**Town of Kittery
 Planning Board Meeting
 January 9, 2020**

ITEM 2 – 76 Dennett Road – Sidewalk Waiver Discussion

Re: Waiver Request - Sidewalks
Proposed Mixed-Use Development at 76 Dennett Road
Lots 6-15B, 6-16A, 13-4, Kittery, Maine

Re: Landscape Design Review for Mixed Use Residential Development Project, Tax Map Lots 6-15B, 6-16A, and 13-4, 76 Dennett Road, Kittery, Maine, 03904

FRONT SITE PLAN
C8

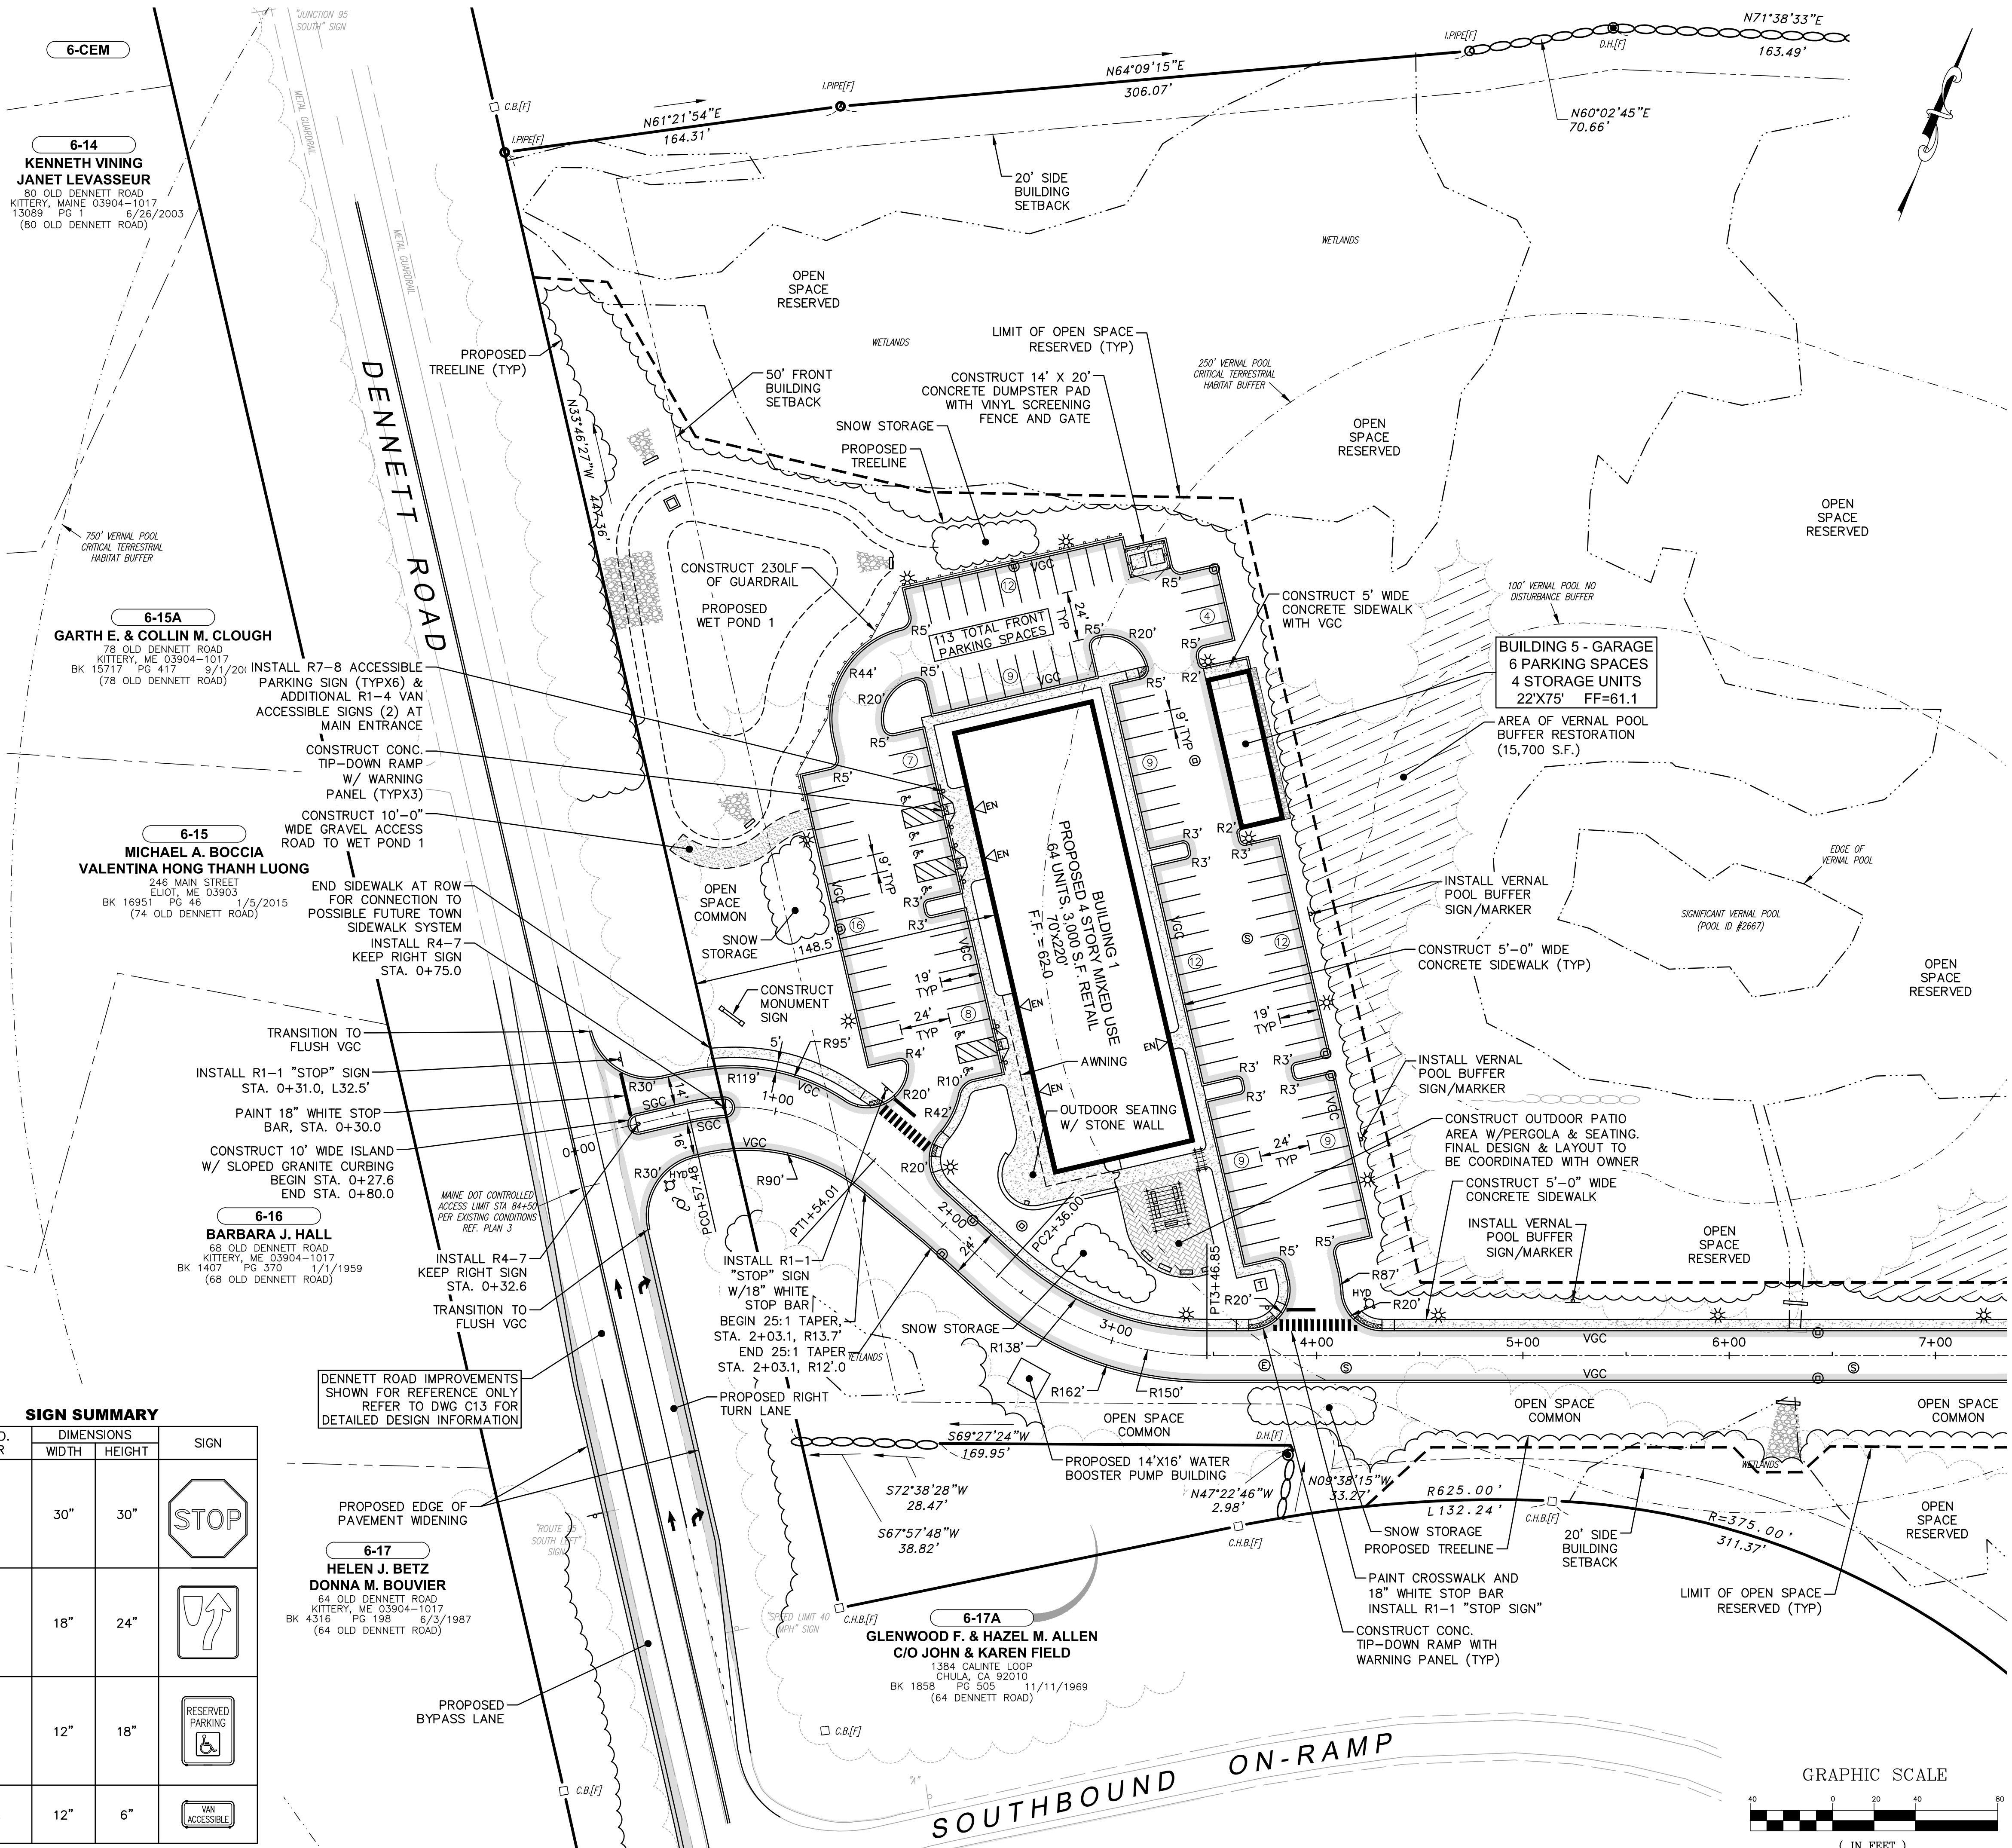
At the Planning Board meeting on December 12th, 2019, the Applicant presented sidewalk plans that showed a sidewalk at the toe of the slope, which would necessitate clearing of existing trees and pose some wetland impacts and a sidewalk located mid-slope which would entail considerable fill and grading plus some clearing of vegetation. The third option which wasn't shown on a plan but was discussed was building the sidewalk within the ROW of Dennett Road. The Applicant's agent stated their position was placing a sidewalk along Dennett Road was risky to pedestrians. The Planning Board did not appear to favor the sidewalk designs (toe of slope and mid-slope locations) shown and asked the Applicant to do two things:

1. Submit a design illustrating how the sidewalk could be built within the ROW of Dennett Road without any clearing of trees
2. Explain why they are seeking a waiver for building a sidewalk

The materials submitted for further discussion are comprised of an application for a waiver and a letter which addresses why the Applicant is seeking a waiver. No plan or standards showing a sidewalk within the ROW was submitted.

Staff believes that MaineDOT likely has sidewalk designs for roads like Dennett Road which could be presented to the Board fairly easily. Staff also recognizes that while this is the first development in the Neighborhood Mixed-Use Zone, others will follow and these may also have frontage on Dennett Road.

Interconnectivity between developments in the Neighborhood Mixed-Use Zone is desirable but is not a substitute for sidewalk along frontage requirements per *16.8 Table 1 Design and Construction Standards for Streets and Pedestrianways*.

It is Hoyle, Tanner’s position that constructing a sidewalk along the frontage of the proposed development would expose pedestrians to high risk conditions. The nearest sidewalk to the site is on the southern side of the S. Eliot Road intersection with Dennett Road, nearly a half mile away from the limit of the proposed site frontage. Constructing a sidewalk along just the development frontage would encourage pedestrians to perform one of two unsafe actions; cross Dennett Road, a 40 mph facility, or cross both the nearby interstate ramps, within the MaineDOT Controlled Access ROW. In regards to the crosswalk option, MaineDOT has specific guidelines on when crosswalks are allowed based on the speed and number of lanes of the roadway (see Table 2 below from MaineDOT Guidelines on Crosswalks). With the proposed combination auxiliary right turn lane and southbound bypass lane, the number of lanes to cross would be 3 or 4 depending on the location. The posted speed of Dennett Road is 40 mph, however the traffic counts performed report an 85th percentile speed of 45 mph. As the table below shows, crosswalks are only allowed on 45 mph facilities at fully actuated traffic signals, which is not warranted for the intersection of the proposed development with Dennett Road.

If the developer were to install the sidewalk along the proposed development frontage, the pedestrians would then have two uncontrolled crossings of the I95 Exit 1 ramps. These crossings present their own challenges as the pedestrian would have to choose between crossing at the edge of Dennett Road, where visibility is the greatest but 120' crossing distances leave them exposed to traffic, or crossing further up the ramps where the distances are reduced to 24' feet but they are no longer visible to traffic until the vehicles have completed the turn, leaving no distance for reaction time.

Both of these options would encourage pedestrians to walk the half mile along either the northbound or southbound shoulder of Dennett Road to connect to the Town's sidewalk network and would lead them to walk beneath the I95 overpass which provides no illumination, exposing both pedestrians and vehicles to a high-risk condition.

The construction of a limited sidewalk section would also pose a problem to the Town for winter maintenance as the snow removal equipment would have to travel a half mile down the shoulder of Dennett Road to clear 640' of unconnected sidewalk. This would often lead to the sidewalk being untreated and not maintained for longer periods of time over the winter months, therefore leading to potential slipping hazards.

Additionally, the construction of a sidewalk would require significant clearing of vegetation and soil fill due to the steep embankments of Dennett Road. Clearing of vegetation would greatly reduce the natural buffer between the proposed development and the existing residential neighborhood.

To comply with the intent of the LUDC, a proposed 7' wide concrete multi-use sidewalk is proposed between the parking at Building 2 and the adjacent parcel. Should this parcel be developed in the future, the 7' wide sidewalk will provide interconnectivity and allow the passage of both pedestrians and bicycles. At the front of the site, a 5' wide sidewalk was extended to the ROW with tip-down ramps and a painted crosswalk. The sidewalk will provide a connection to a possible future Town sidewalk system should one be designed and constructed to S. Eliot Road as part of the Town's overall sidewalk master planning. Within the site, all roadways and parking areas provide adequate sidewalks per the LUDC design standards. The site itself has nearly a mile of interconnected sidewalks and walking trails.
